INQUIRY INTO ROAD SAFETY IN TASMANIA

Los Angelos Road/Sanwae Drive intersection

After recent roadworks at the intersection of Los Angelos Road and Sanwae Drive, Swan Bay, the residents and the broader community that use this intersection have some safety concerns regarding the design.

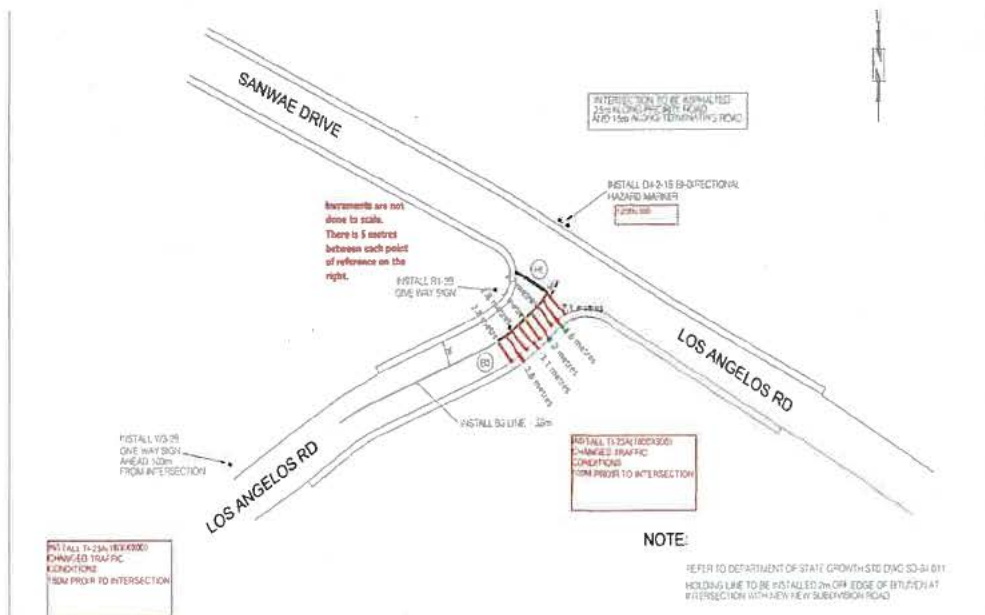
Above picture shows driver turning right into Los Angeles Road from Sanwae Drive, undoubtedly cutting the corner. This was not an isolated incident in the time that we were there.

Similarly, the junction layout is sufficient for light vehicles to turn right into the junction without crossing the centreline, the example you have provided is an example of poor driver behaviour; this happens at many locations across the road network. Sufficient sight distance is available to drivers to observe vehicles throughout the intersection so that these drivers may modify their behaviour to avoid a collision.
